**विषय:** Consultancy Services for Preparation of DPR for Four Laning of Ghazipur-Ballia-UP/Bihar Greenfield Section from Km. 0.000 to Km. 115.200 of NH-19 including Buxar Spur (Length: 17.800 Km.) in the State of Uttar Pradesh.

*Sub: Diversion of 5.66 ha of Protected forest land in favour of National Highway Authority of India, PIU, Azamgarh for construction of four lane from Ghazipur to Ballia-U.P./Bihar Border New Greenfield section from Km 0.00 to Km 115.200 of NH-19 and construction of new Buxar spur connectivity (Length:17.800 km) including upgradation along the existing alignment under Saran Forest Division in-Saran district of Bihar-reg.*

**Replies regarding Observations on Forest Diversion Proposal in Bihar State for 5.66 Ha -reg**

## Annexure-I

TYPICAL CROSS SECTIONS  
TCS IV A

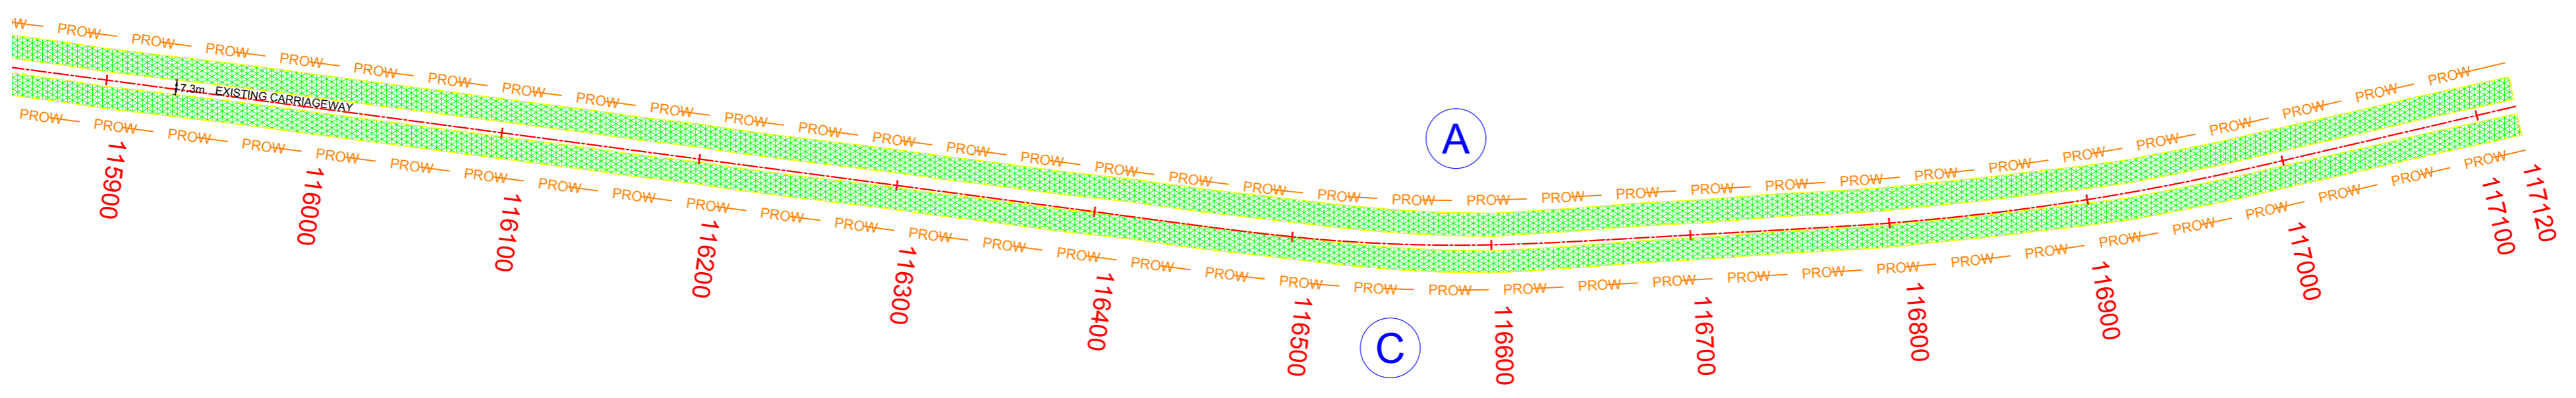
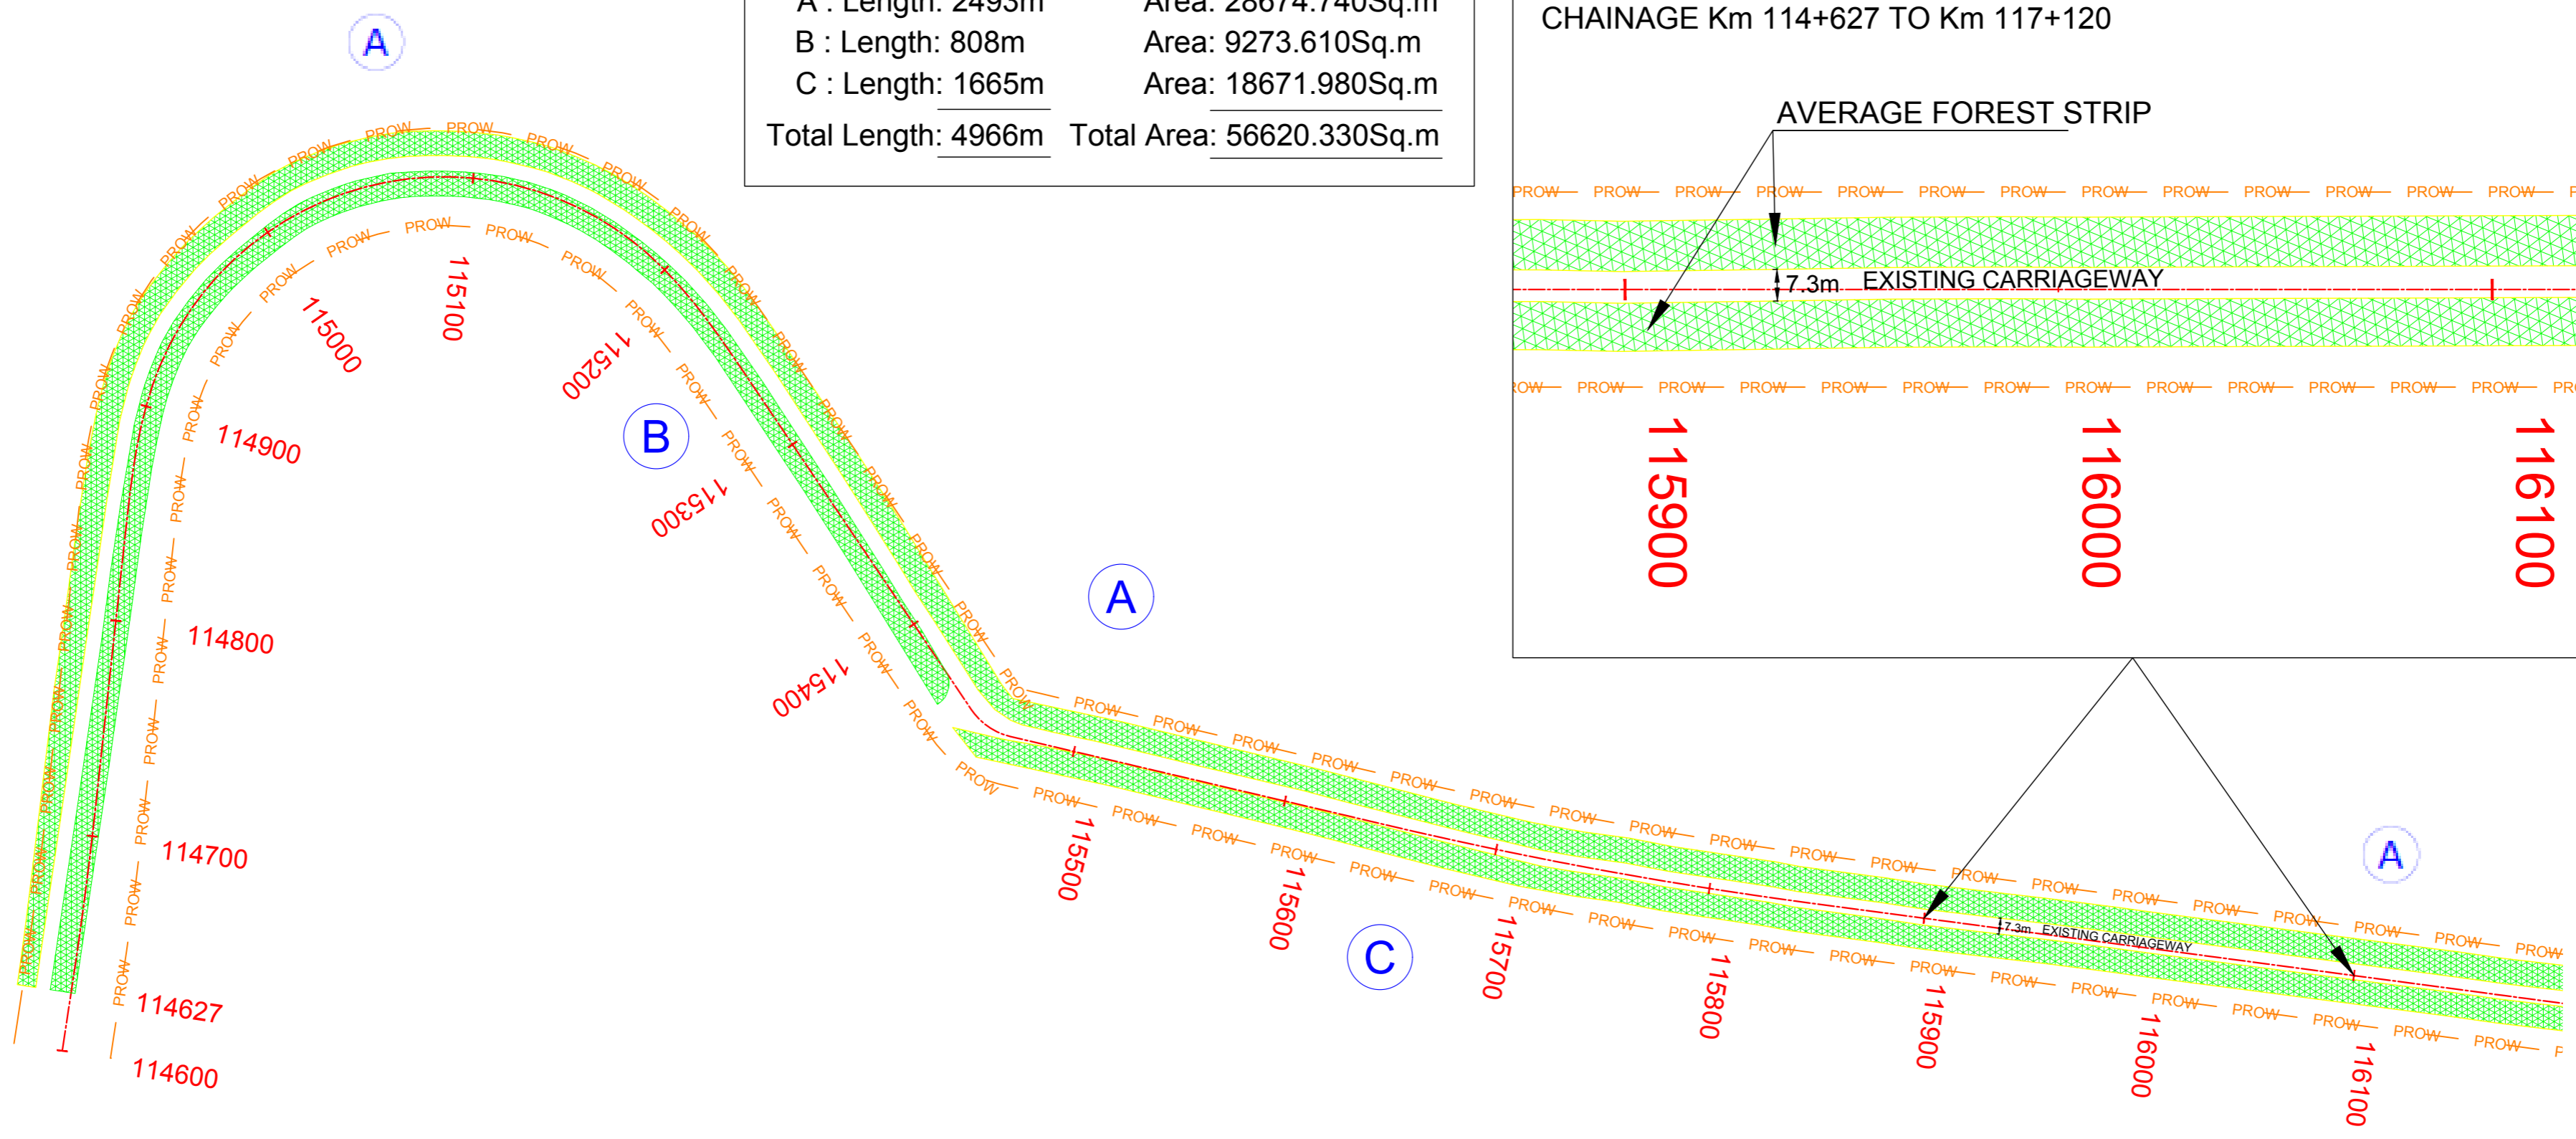
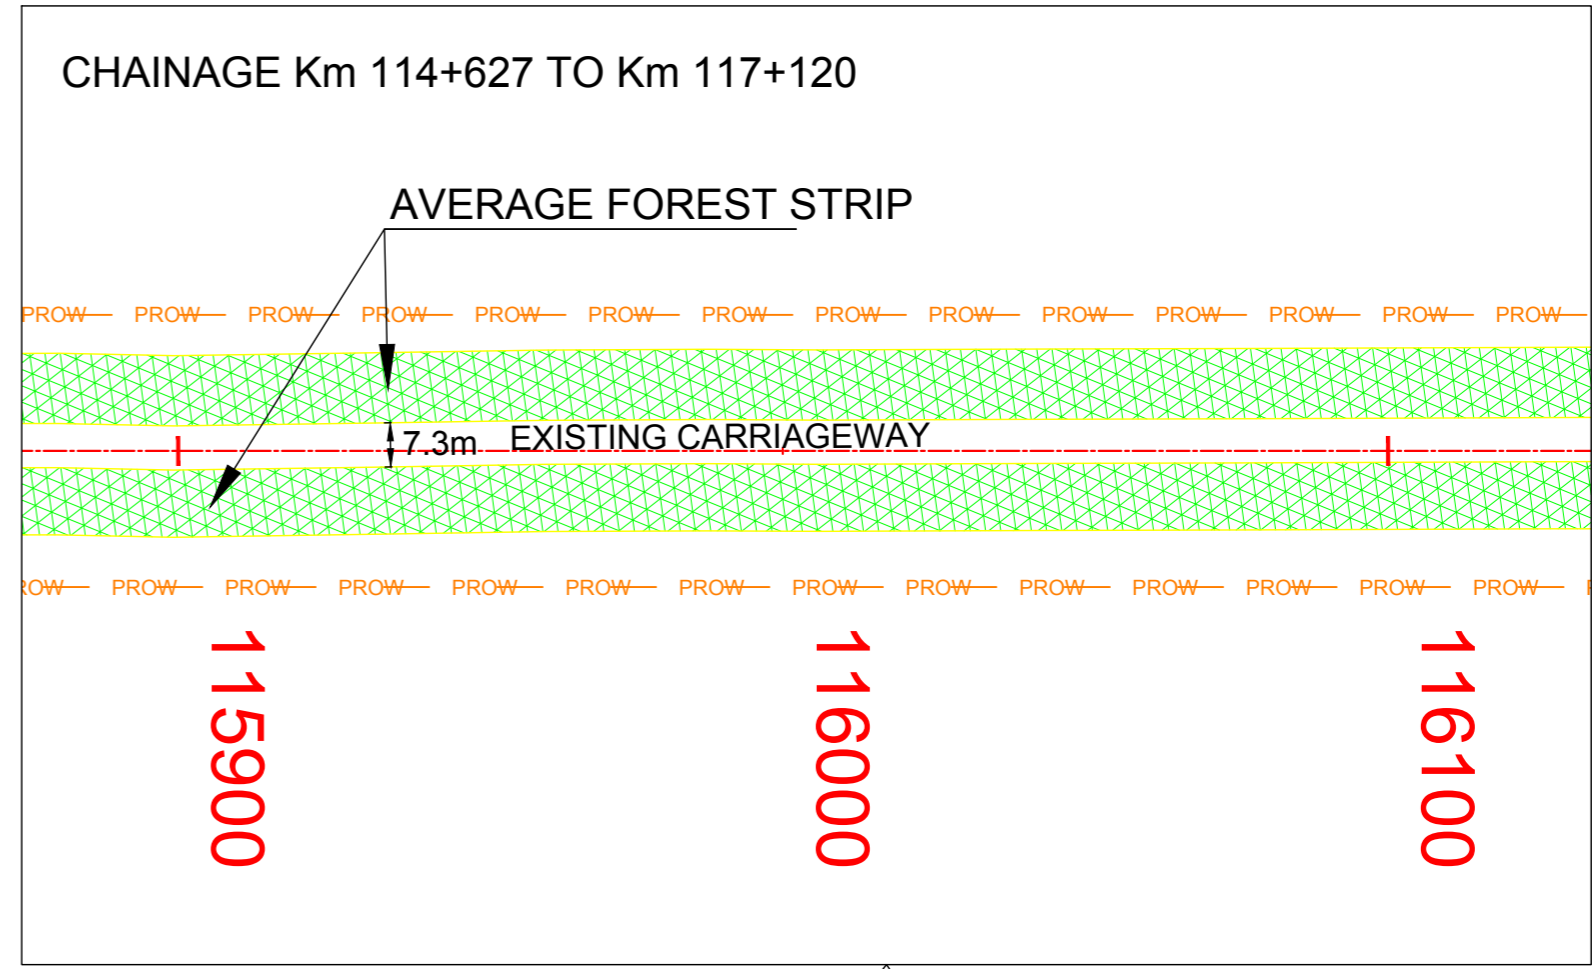
- x. The X-section map duly signed & sealed by NHAI needs to be uploaded on the PARIVESH portal.
- xi. The area proposed for diversion is 5.66 ha. but as per GIS-DSS analysis, the proposed diversion area is 3.79 ha. in kml file. This needs rectification/clarification.

10	The X- section map duly signed & sealed by NHAI needs to be uploaded on the PARIVESH portal.	Please find attachment – IV for the signed X – section of the proposed alignment that was uploaded on the portal
11	The area proposed for diversion is 5.66 Ha but as per the GIS – DSS analysis, the proposed diversion area is 3.79 ha. In kml file. This needs rectification / clarification.	Please find the attachment – V for the revised kml and the same has been uploaded on the portal
12	Clear and high resolution Toposheet of the CA land needs to be uploaded on the PARIVESH portal. The existing Toposheet (on PARIVESH portal) is not clearly visible. This needs to be re uploaded on the portal.	To be uploaded by the DFO

# Forest Location (L6)- Sahabalpur

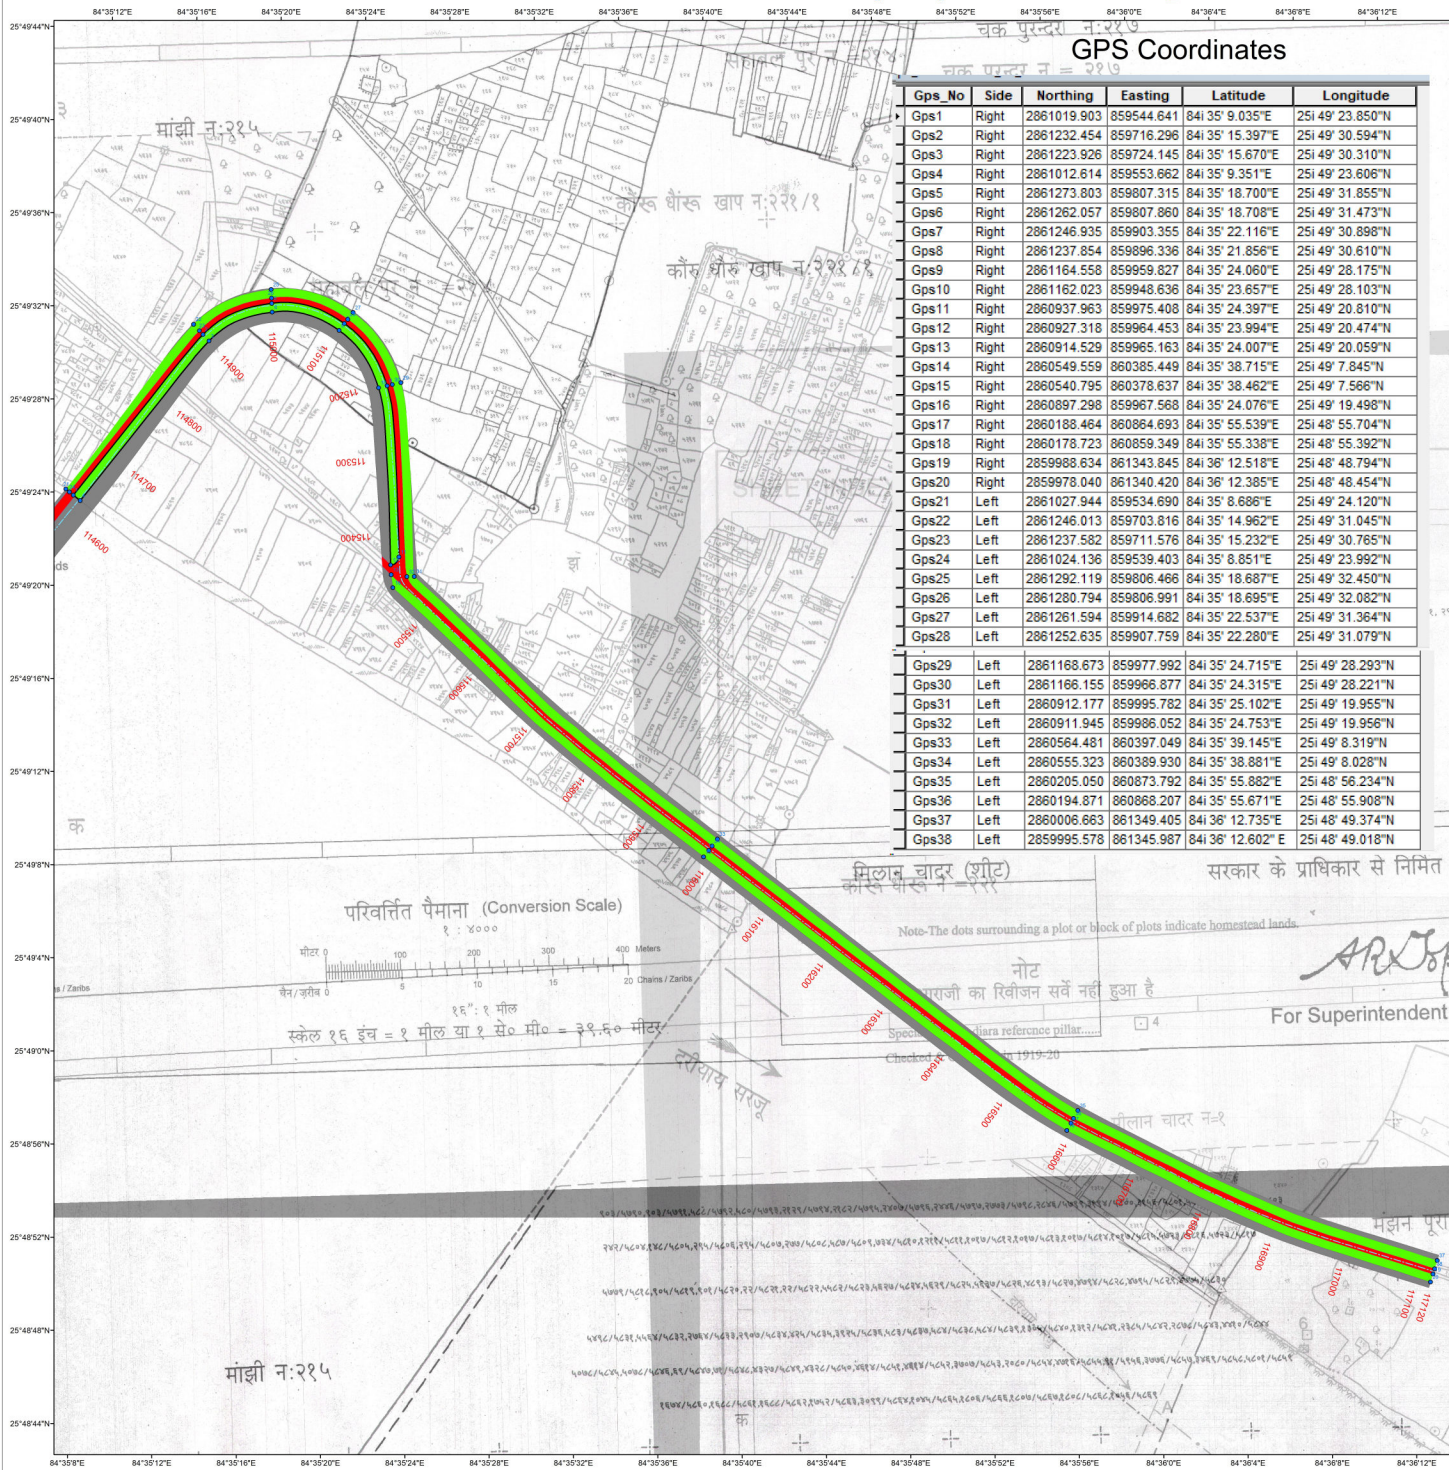
- iii. The area calculation sheet duly approved by the concerned DFO needs to be uploaded on the portal.
- iv. Approval details of the existing road proposed for widening need to be uploaded on the portal.

3	The area calculation sheet duly approved by the concerned DFO needs to be uploaded on the portal.	Please find the attachment – I for the approved area calculation sheet by the DFO
4	Approval details of the existing road proposed for widening need to be uploaded on the portal	Please find the attachment – II for the approval letter issued by the MoRTH
5	It is not clear from the proposal what is the status of the widening before and after the proposed alignment.	The existing two-lane road is being proposed for 4 lane road with median and paved shoulders.
6	Geo – referenced map of the proposed CA area duly approved by the concerned DFO needs to be uploaded on the portal.	The concerned DFO may upload this document
